FINAL DECISION
AusNet Services distribution
determination
2016 to 2020

Attachment 11 – Service target
performance incentive scheme

May 2016

Figure 11.1 Historical Victorian VCR (nominal)

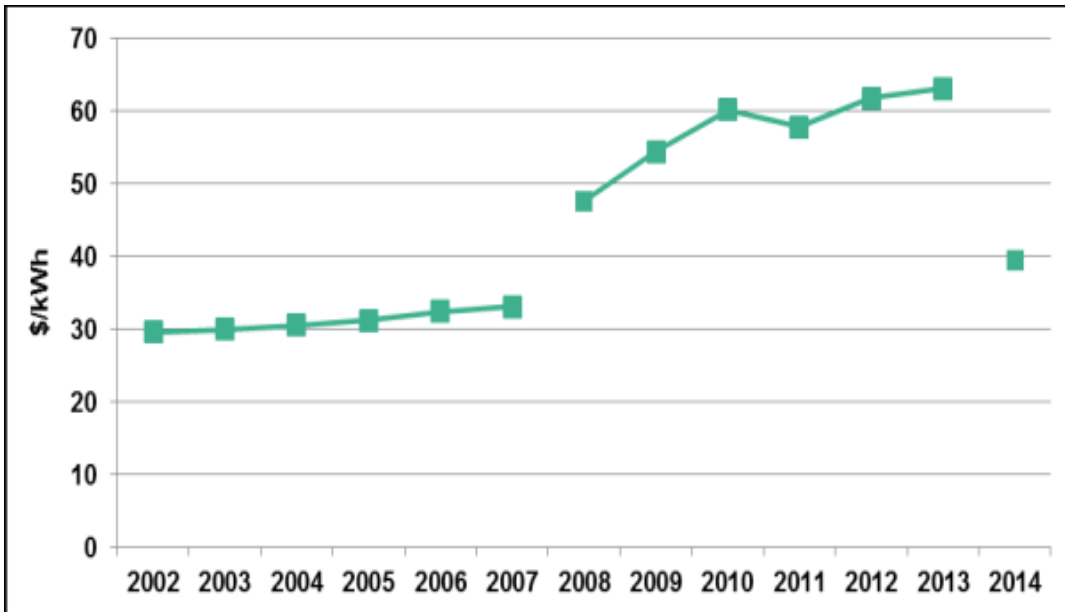
There has been no net movement in the value of the VCR between the two regulatory periods commencing in 2006 and 2011 respectively (see Figure 11.1), for the purpose of setting STPIS targets:

- In the 2006–10 determination (by the Essential Services Commission of Victoria), a VCR of \$39.46 per kWh (\$ 2014) was used as the basis for setting the incentive rates of the previous Victorian equivalent of the STPIS.²⁵
- In the 2011–15 distribution determination, a VCR of \$54.92 per kWh (\$ 2014) was used to calculate the incentive rates. However, the performance targets for the 2011–15 period were based on the actual performance outcomes of the 2006–10 period when the VCR was \$39.46 per kWh (\$ 2014) without adjustments.
- The most recent study by AEMO indicates that the Victorian state-wide VCR is now \$39.50 per kWh (\$ 2014)—practically at the same level as the 2006–10 period.

AusNet Services revised regulatory questioned the relevance of the above points and stated that the schemes applied in 2006–10 were different to those 2011–15.

We do not agree with this submission. We consider that, while the scheme in name may be different, the application of the scheme and the scheme design are essentially

Figure 11.2 Historical SAIDI

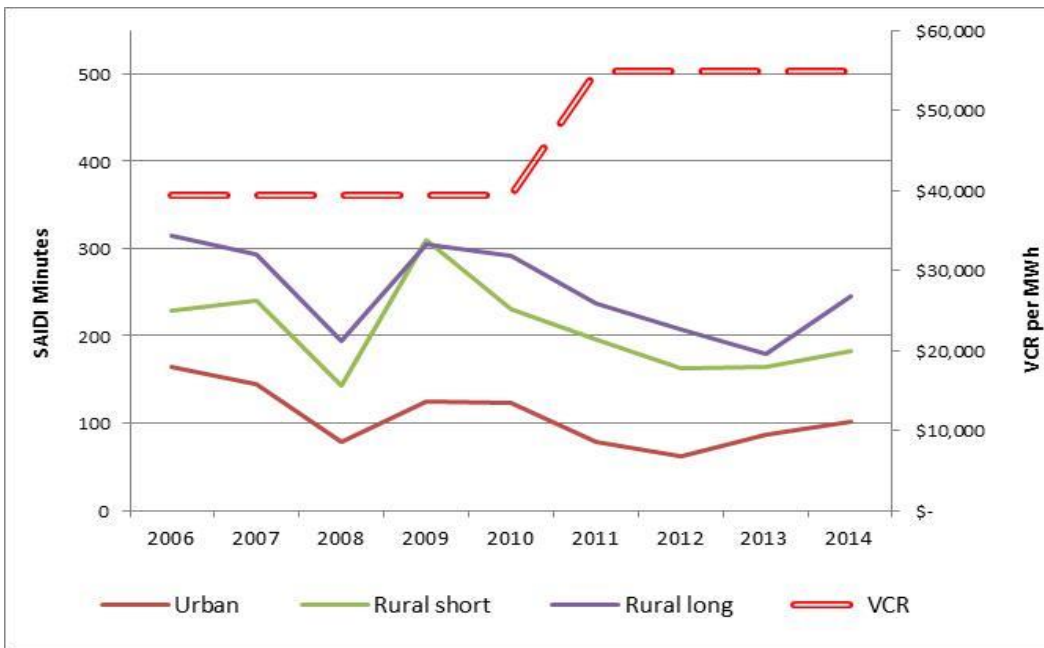
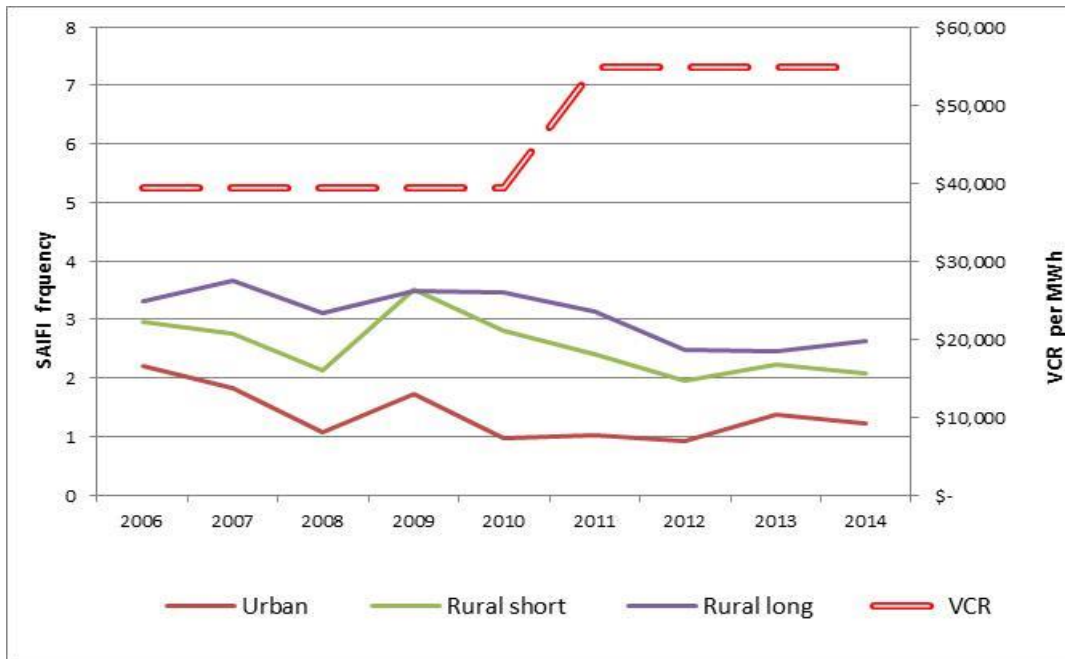
the VCR will impact on reliability immediately as claimed.²⁷ AusNet Services asserts that applying a lower VCR for capex purposes will result in a decline in reliability in the next regulatory period. Contrary to the above assertion concerning the effect of VCR on reliability performance, AusNet Services attributed its improved reliability performance in the current regulatory period to other factors (see below) and not to the increase in the VCR value (see Figure 11.2 and Figure 11.3).

As such, we consider that the improvement is more likely due to the higher level of incentives approved for AusNet Services in the current period (higher than the normal STPIS scheme standard of ± 7.0 per cent revenue at risk; and a 2.8 beta threshold for major event day (MED) exclusion level—the higher the beta the lesser the number of MED events that can be excluded and a higher level of accountability on the distributor's performance outcome). In effect the scheme was adjusted to provide both higher incentive rates and revenue at risk (greater rewards and penalties) over the current period.
